NOTICE OF ADDENDUM  
ADDENDUM NO. 1  
CONTRACT NO. 8504  
CEDAR STREET ASSESSMENT DISTRICT – 2021 & SOUTH STREET, HIGH STREET, AND WEST  
WINGRA DRIVE ASSESSMENT DISTRICT – 2021

Revise and amend the contract document(s) for the above project as stated in this addendum, otherwise, the original document shall remain in effect.

DATE	BY	Scale: 1" = 40'	P-5
REVISION	DATE		
MARK	DESIGNED BY: AJZ	12956	
12956		MADISON, WI	8504
SOUTH STREET PLAN AND PROFILE		CONTRACT NO:	
CEDAR ST, SOUTH ST, HIGH ST, WINGRA DR PROJECT		M:\DESIGN\Projects\11866\CAD\Plan Sheets\12956EN-PnP SouthSt.dwg	
		12956	P-5

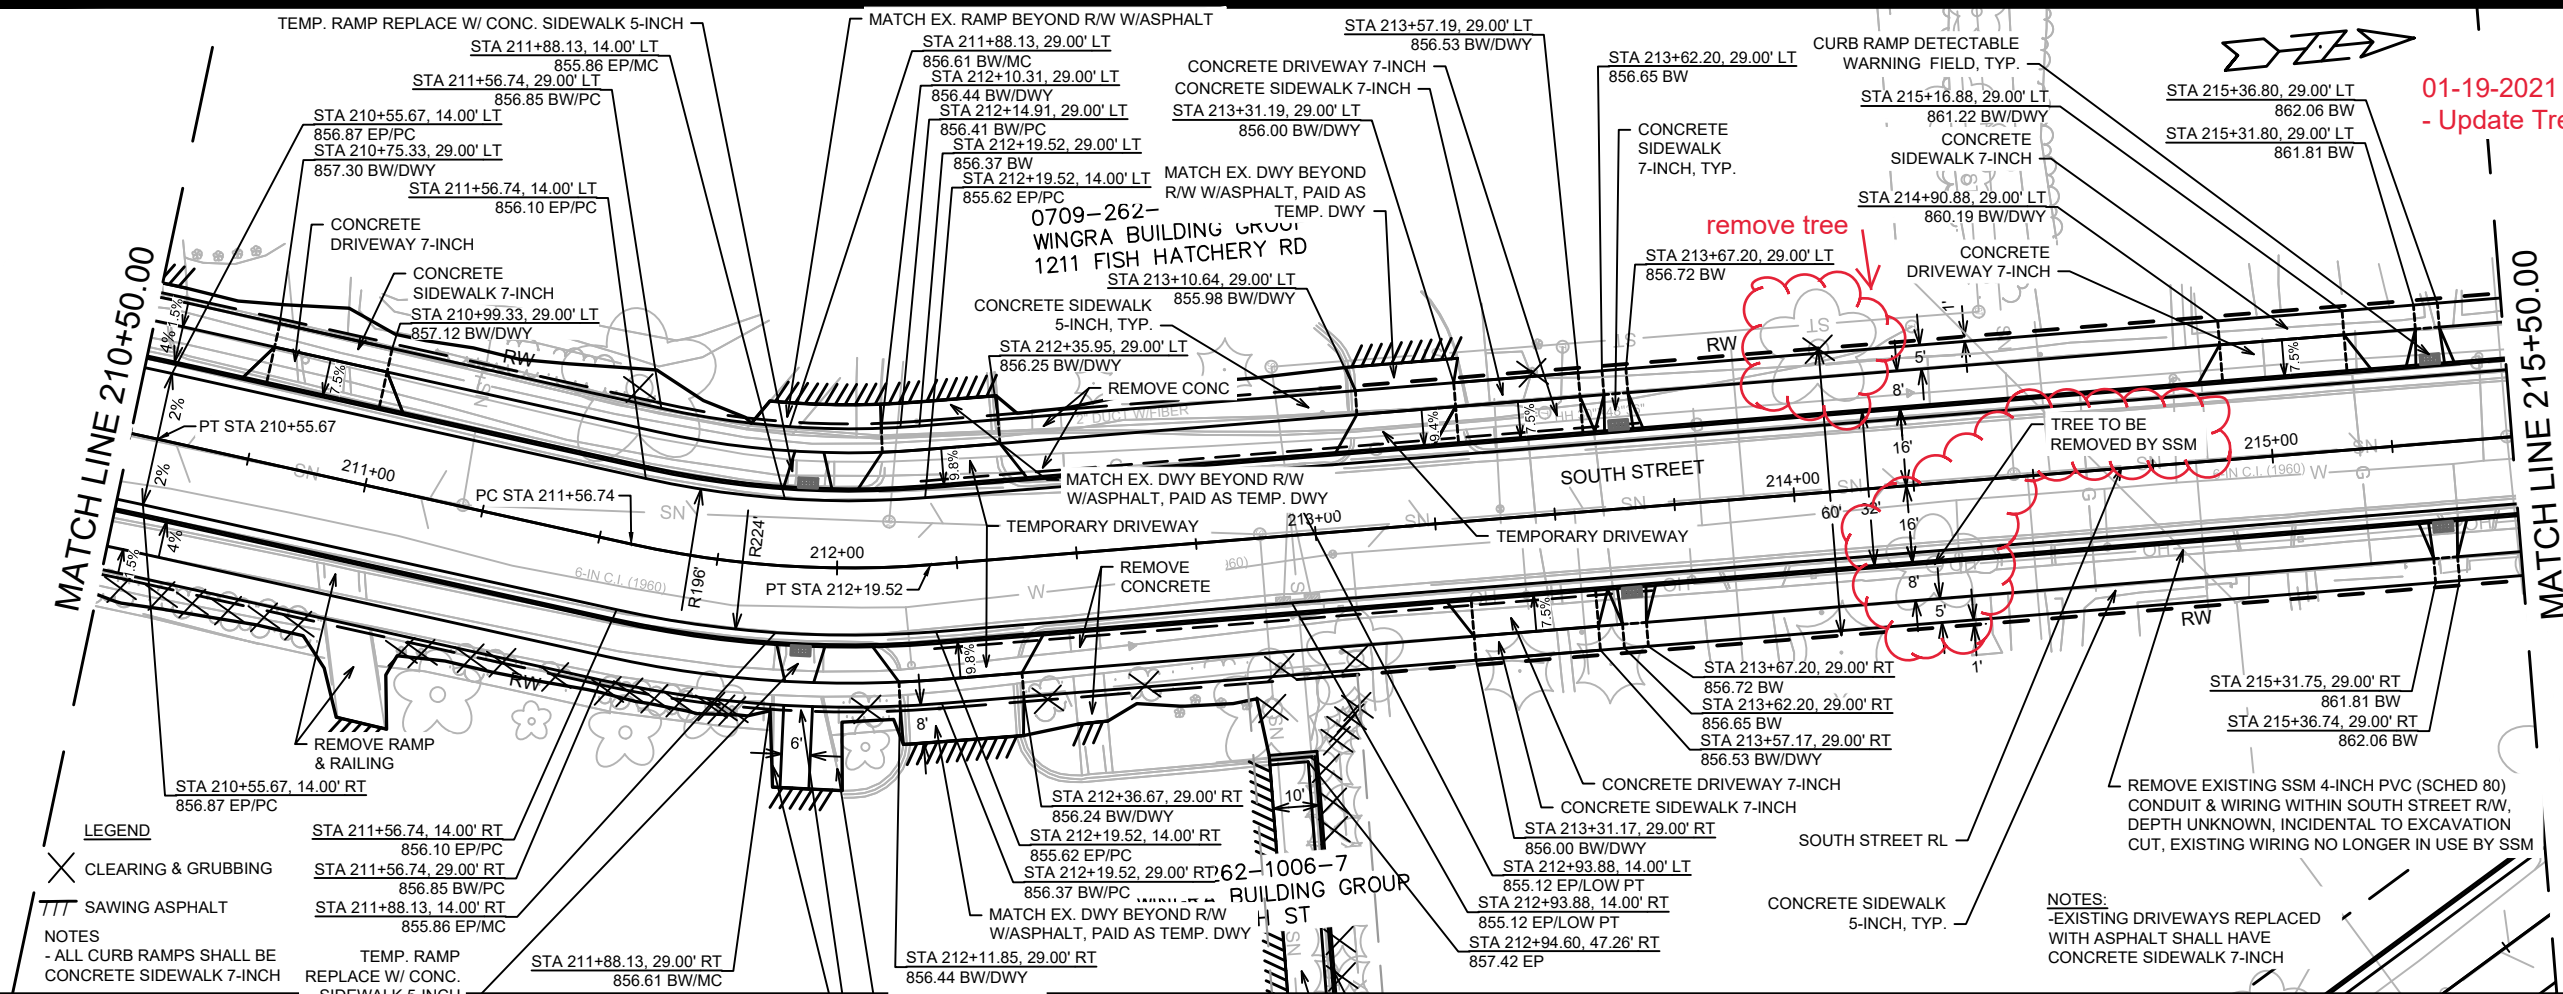
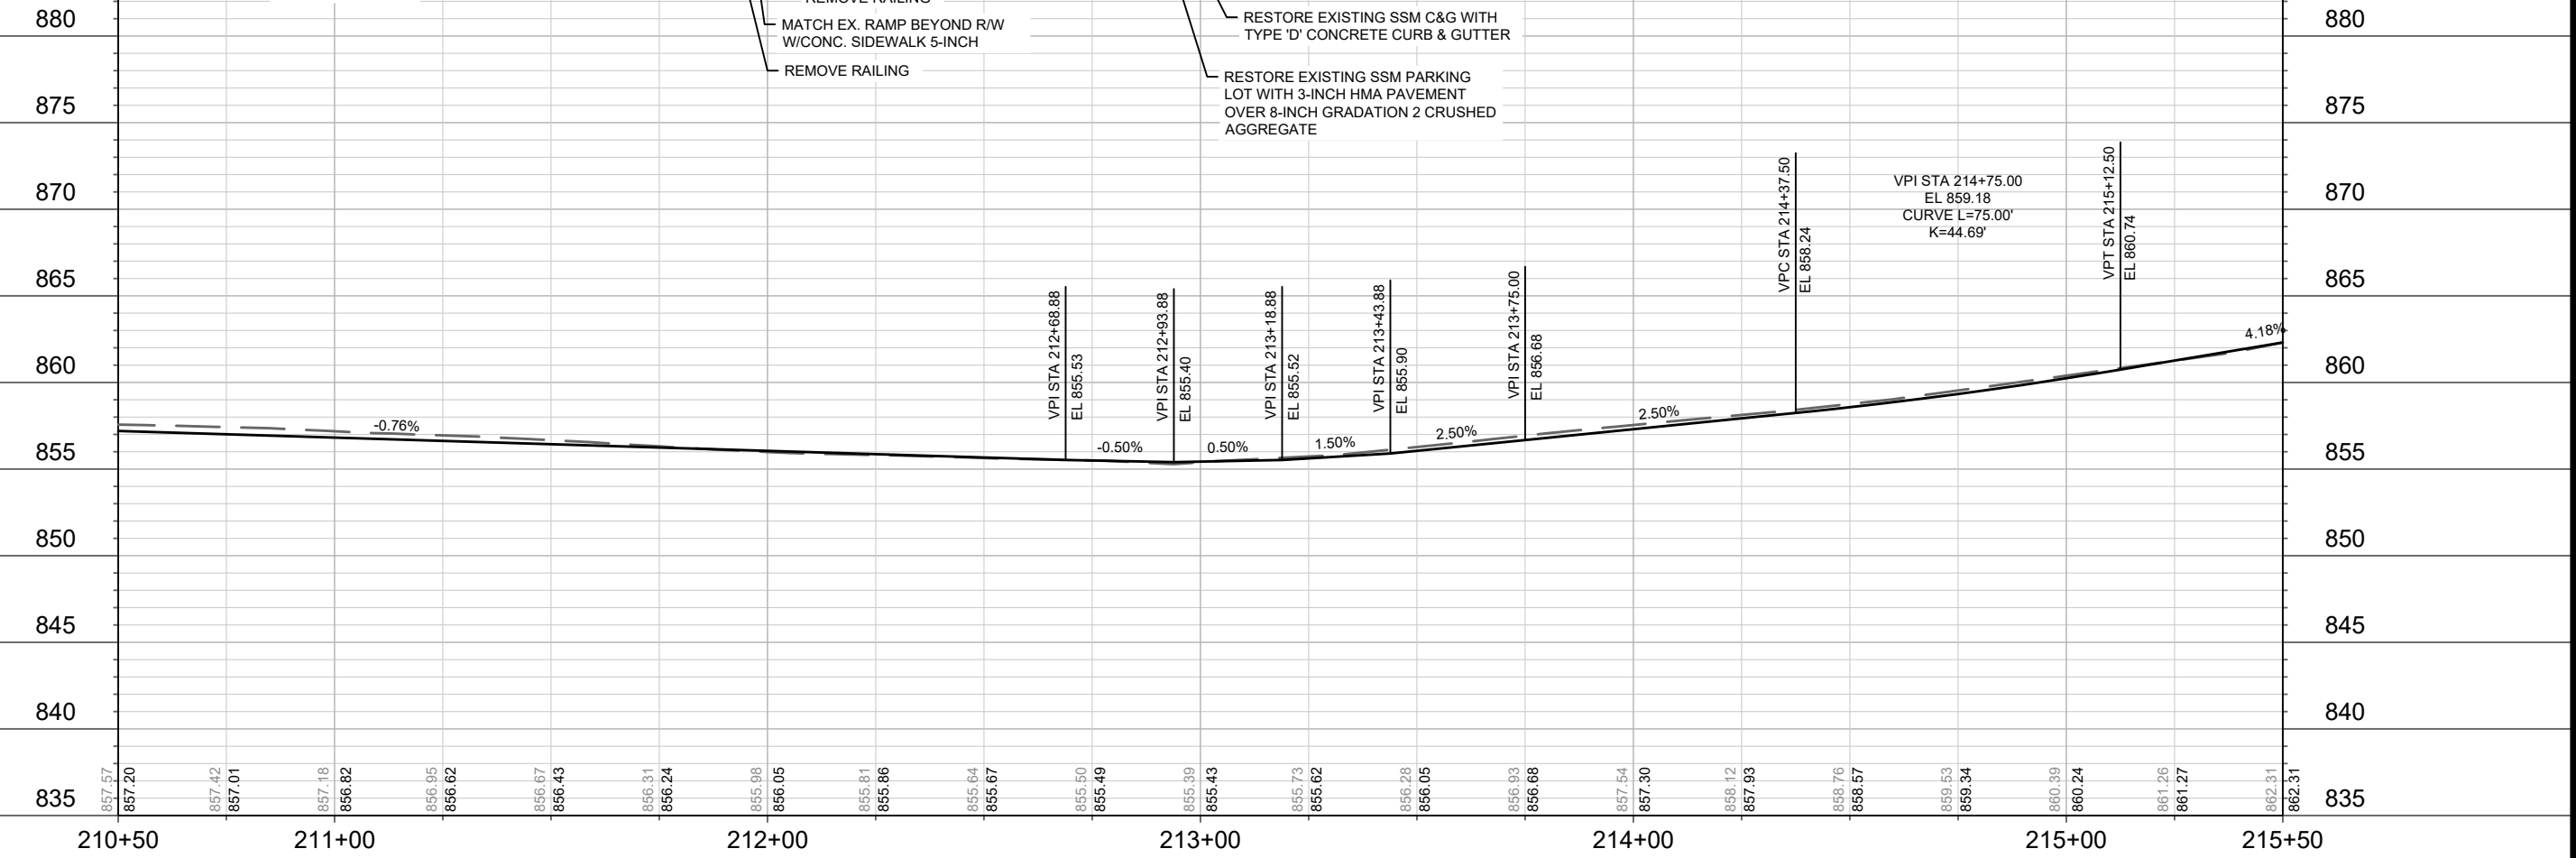
P-5, P-6, & P-7: Updated plans with additional tree removals.

01-19-2021 Addenda 1 AJZ  
 - Update Tree Removal Information

DATE	BY
REVISION	
MARK	
DESIGNED BY: AJZ	DATE: 1/13/2021 9:07 AM
12956	
P-7

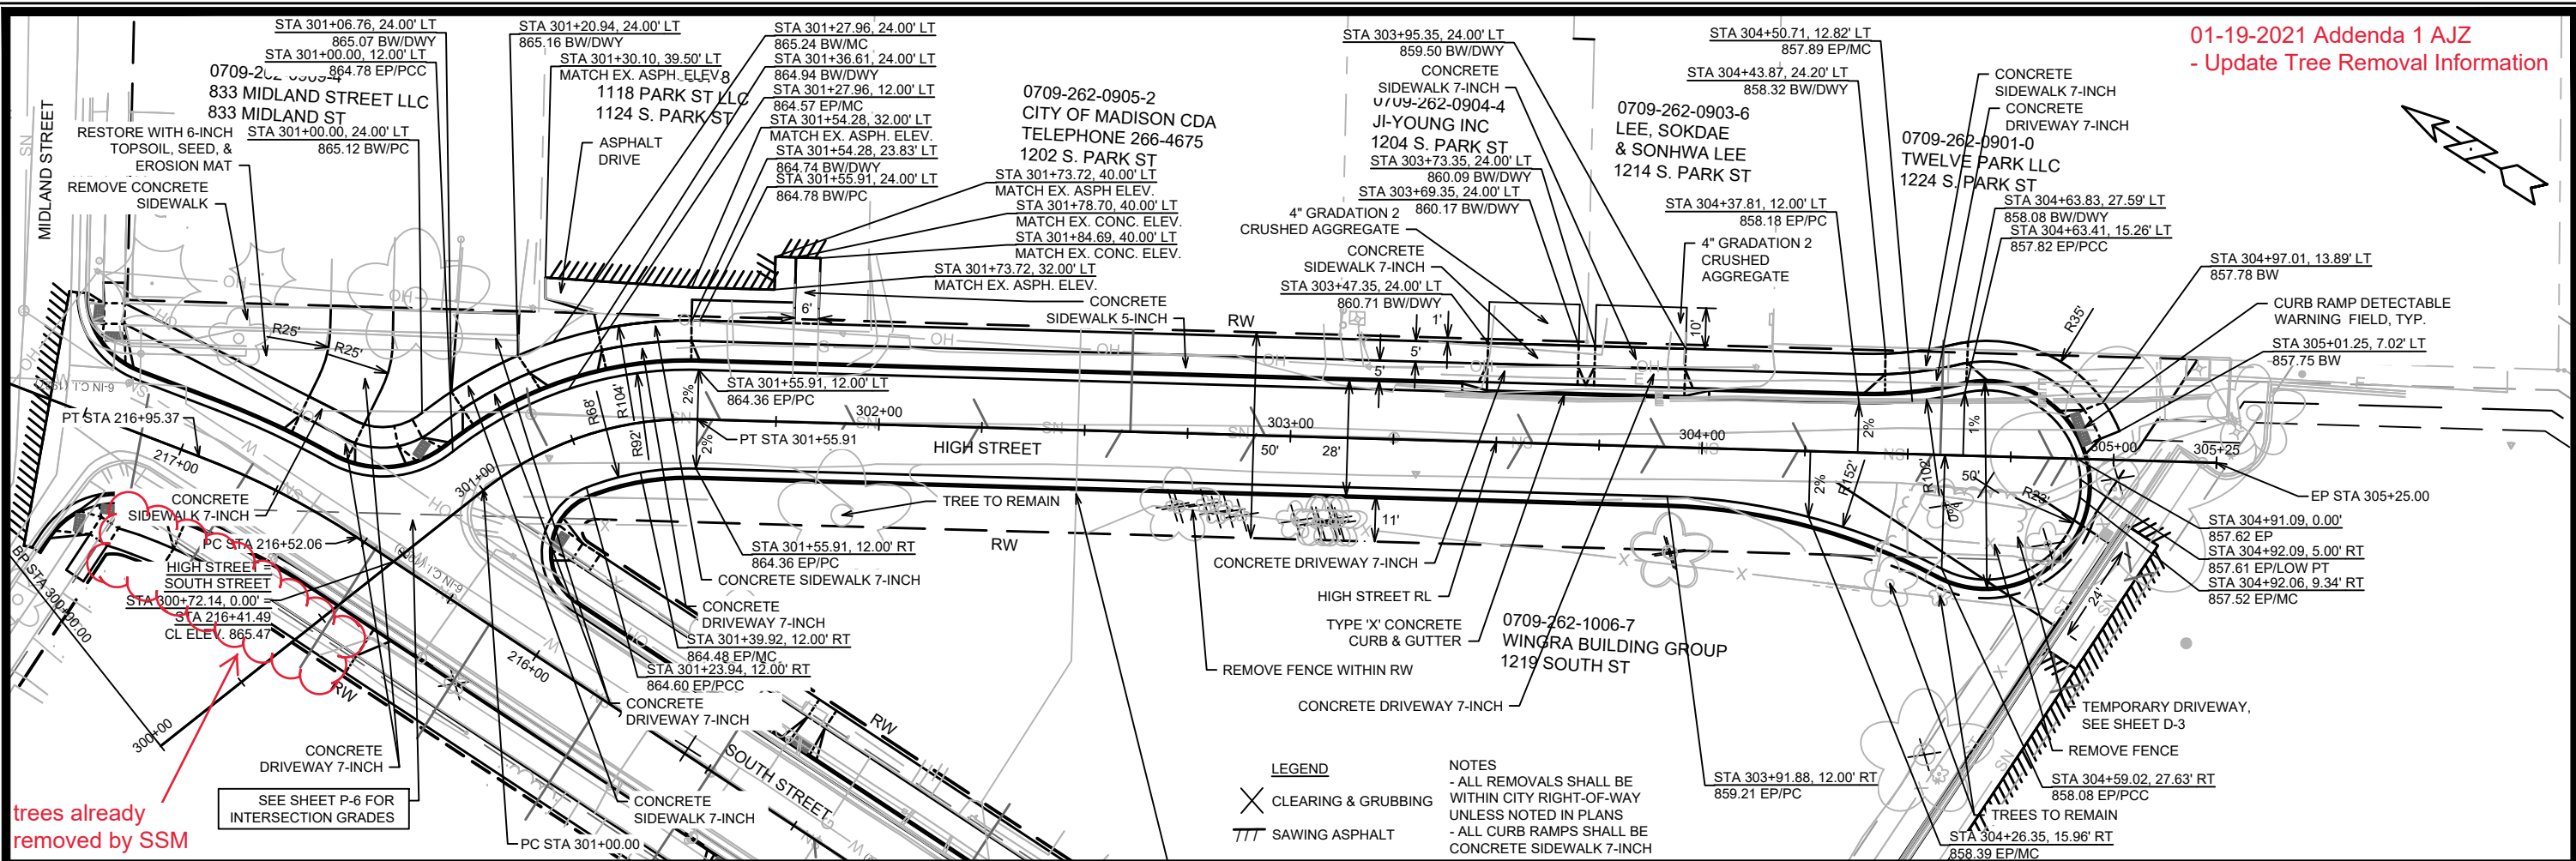
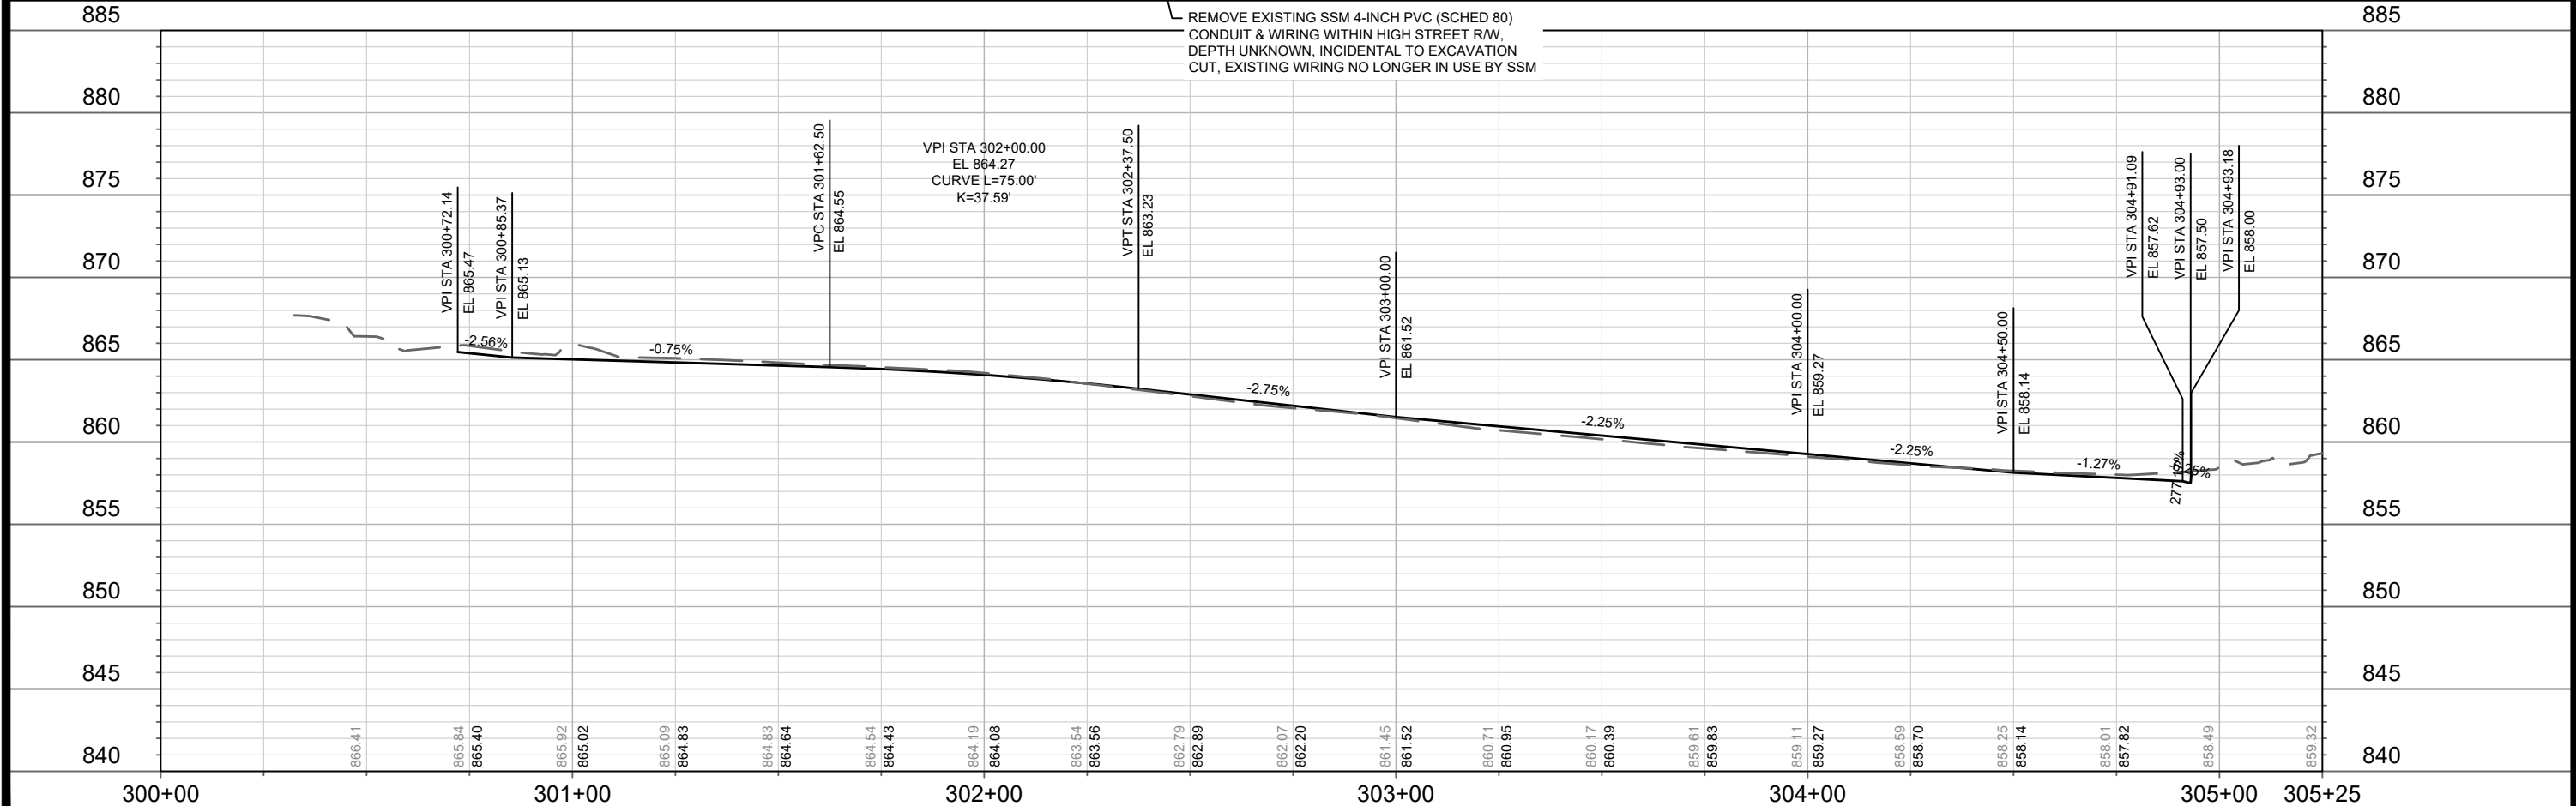
01-19-2021 Addenda 1 AJZ  
 - Update Tree Removal Information

trees already removed by SSM
